Heater Hose Reduced Clearance May Cause Early Horn Failures

83-161

**Freightliner
Service Bulletin**

Description of Revision: *This bulletin replaces the version dated 08/25/2021. The bulletin title has been revised.*

Fig. 1, Heater Hose Adjacent to Electric Horn

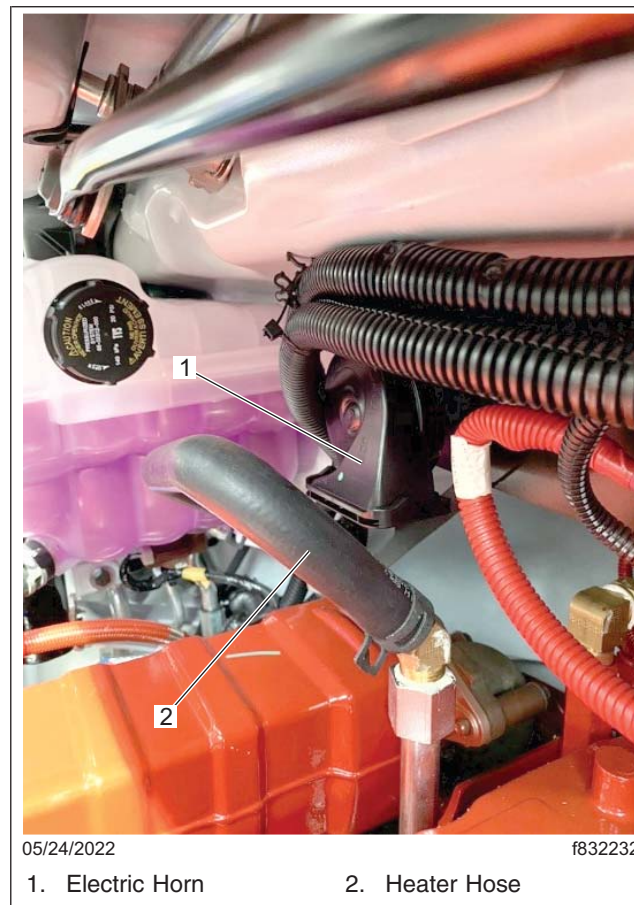
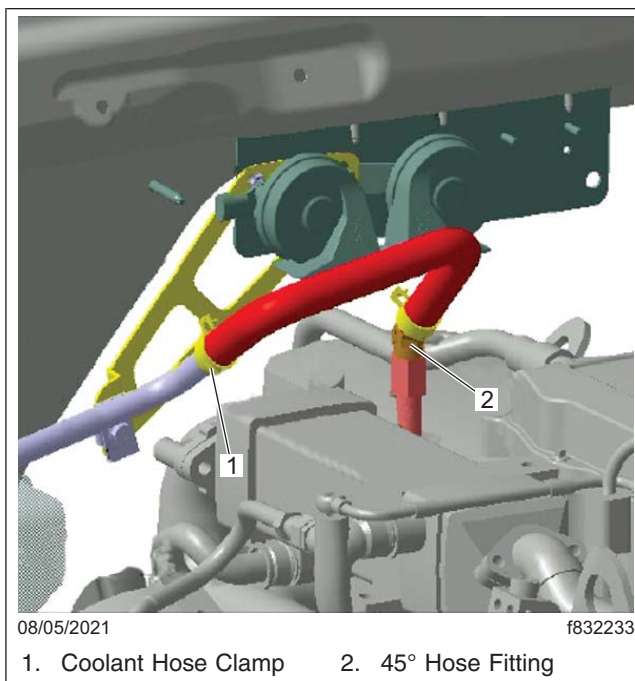
Some Business Class M2 106 vehicles built from January 2017 through June 2021 may have a heater hose installed too close to the vehicle's electric horn(s). This service bulletin applies to Business Class M2 106 vehicles with a 160 mm cab equipped with Cummins ISB engines with either single or dual horns. It also applies to heater systems with or without automatic shut-off valves. Horn failures have been reported due to high heat produced by the heater hose. In some cases, the horn comes in direct contact with the heater hose. See [Fig. 1](#).

Fig. 3, Tube Reflecting Sleeve

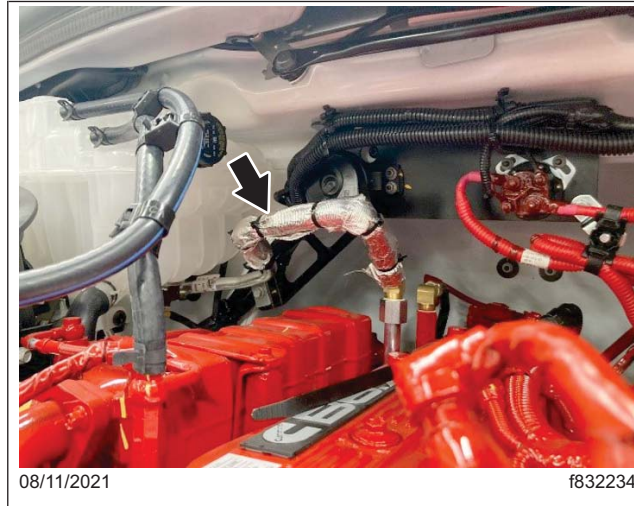
- 6.2 Remove the 45 degree fitting shown in **Fig. 2**. Use a wrench to hold the end of the heater coolant supply tube as you remove the fitting.
7. Install the tube reflecting sleeve (part number BEN 476445028) on the heater hose and secure it with tie straps. See **Fig. 3**.

NOTE: The additional 90 degree fitting is not required if the heater coolant system is equipped with an optional supply shut-off valve. In this case, only install the tube reflecting sleeve.

Fig. 4, Updated Heater Hose Installation

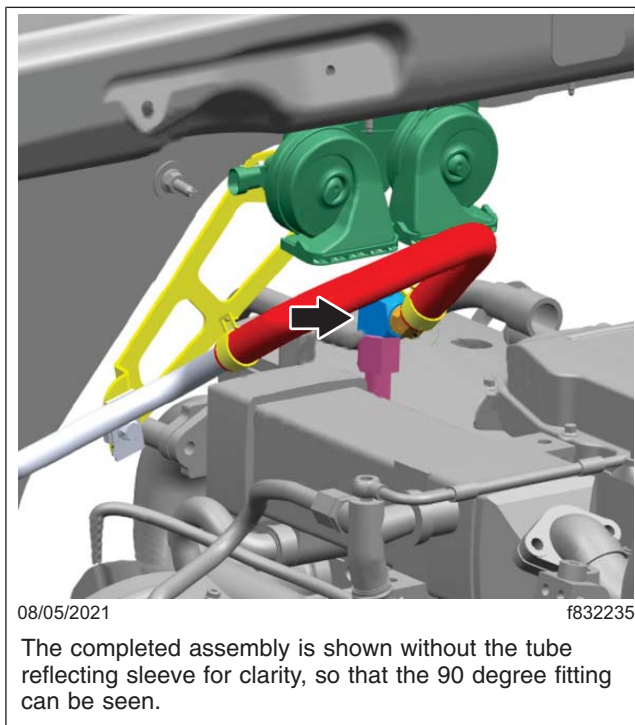
8. Attach the 90 degree fitting (part number 210503 000027) under the 45 degree fitting. See [Fig. 4](#).

- 8.1 To prevent coolant leaks, apply Loctite® 592 thread sealant to both the 90 degree fitting and the 45 degree fitting before assembly. See [Fig. 5](#).

- 8.2 Tighten the fitting assembly by hand.
- 8.3 Using a wrench to hold the end of the coolant supply tube, attach the fitting assembly to the tube. Tighten the fitting assembly 40 lbf-ft (54 N-m).
- 8.4 Attach the heater hose to the fitting assembly and secure it with a clamp (part number 23-09796-309).

Fig. 6, Single- and Dual-Horn Installation

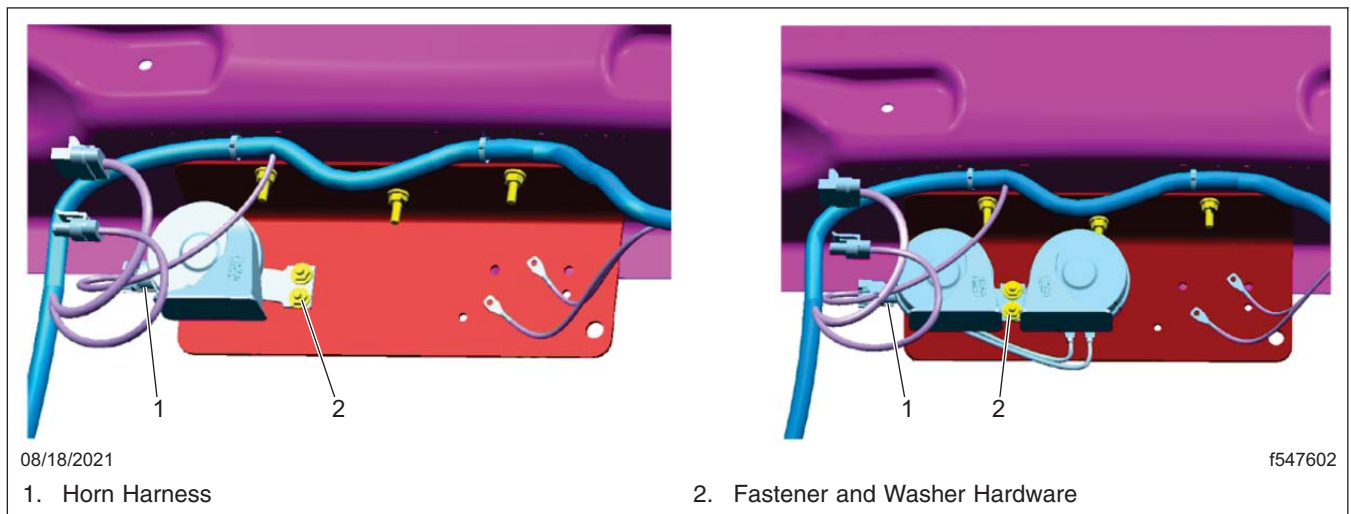
1. Unplug the horn harness.
2. Remove the two fastener and washer hardware sets. See [Fig. 6](#).

3. Replace the single- or dual-horn part numbers with the same part number or replacement part, per available Paragon information. Use the removed hardware to install the horn(s). Tighten the fasteners 48 to 60 lbf-in (542 to 678 N·cm).
